## ORIGINATION FORM

### Proposed Revisions to a Standard Plans Index

Index Number: 400-010  
Sheet Number (s): 2 of 2  
Index Title: Cantilever Retaining Wall (C-I-P)

TYPICAL BACKFILL DETAIL

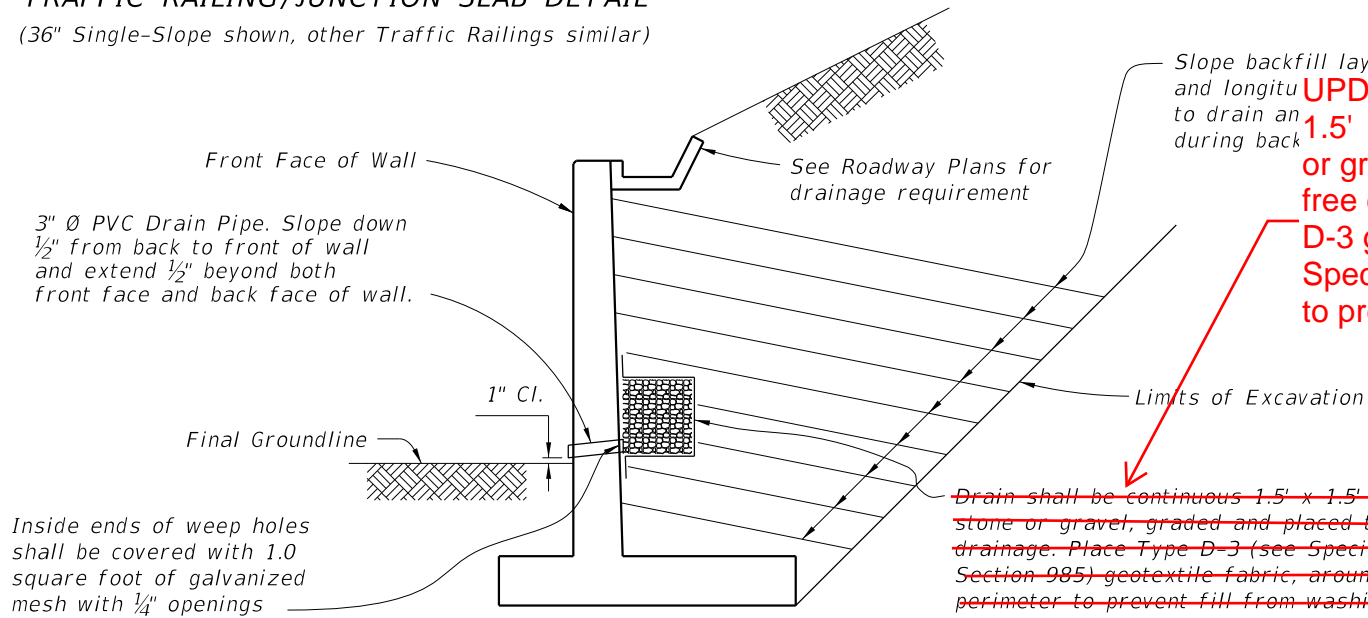
Sheet 2: Updated the TYPICAL BACK-FILL DETAIL Callout: " Install a continuous 1.5' x 1.5' drain using clean, broken stone or grave, graded and placed to allow free drainage. Provide and install Type D-3 geotextile in accordance with Specifications 514 around th perimeter to prevent fill from washing out."

~~Drain shall be continuous 1.5' x 1.5' clean, broken stone or gravel, graded and placed to allow free drainage. Place Type D-3 (see Specification Section 985) geotextile fabric, around the perimeter to prevent fill from washing out.~~

**UPDATED: Install a continuous 1.5' x 1.5' drain using clean, broken stone or grave, graded and placed to allow free drainage. Provide and install Type D-3 geotextile in accordance with Specifications 514 around th perimeter to prevent fill from washing out.**

SECTION A-A  
EXPANSION JOINT DETAIL

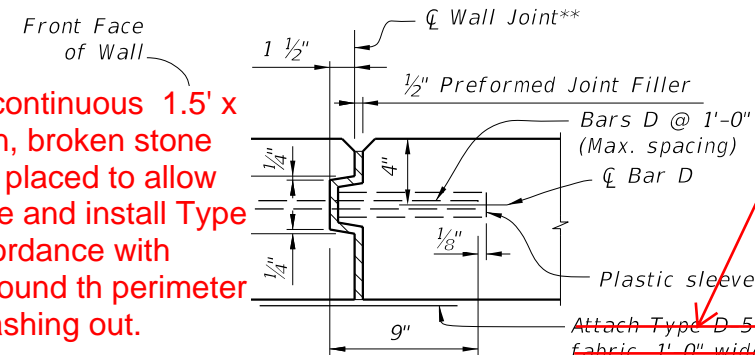
Updated the EXPANSION JOIND DETAIL (SECTION A-A) Callout: "Provide and install Type D-5 geotextile in accordance with Specifications 514. Attach geotextile, 1'-0" wide and full height to fill, to the back of wall with an adhesive approved by the Engineer."

~~Attach Type D-5 (see Specification Section 985) Geotextile fabric, 1' 0" wide and full height of fill, to the back of wall with an adhesive approved by the Engineer.~~

**UPDATED; Provide and install Type D-5 geotextile in accordance with Specifications 514. Attach geotextile, 1'-0" wide and full height to fill, to the back of wall with an adhesive approved by the Engineer**
